AUTHORIZED FIELD CHANGE G-10921

Navistar has decided to perform an authorized field change campaign on certain 5900, 7600, 8600, and ProStar model trucks built 5/27/10 thru 9/15/10 with a MaxxForce 13 engine equipped with a 4-tab style oil filter.

**Incorrect Oil Filter
Housing**

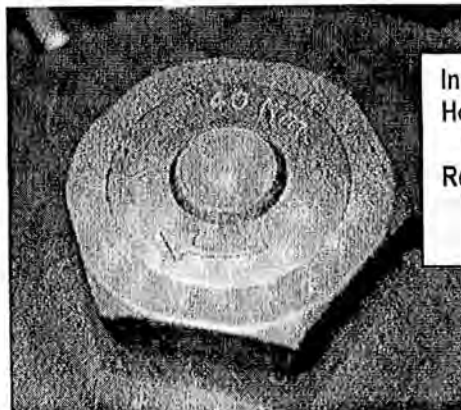
The suspect vehicles may have been built with an engine having a discontinued oil filter design. The replacement oil filter does not fit properly in the housing for the discontinued filter possibly allowing oil to by-pass the filter.

The picture below is of the incorrect oil filter housing cover. Notice that the center circular section protrudes outward.

Repair Required

If your vehicle is equipped with the incorrect housing, please schedule an appointment with any INTERNATIONAL® dealer to have your vehicle repaired. You can find your nearest dealer by calling 1-800-448-7825 or by using the dealer locator at <http://www.internationaltrucks.com>.
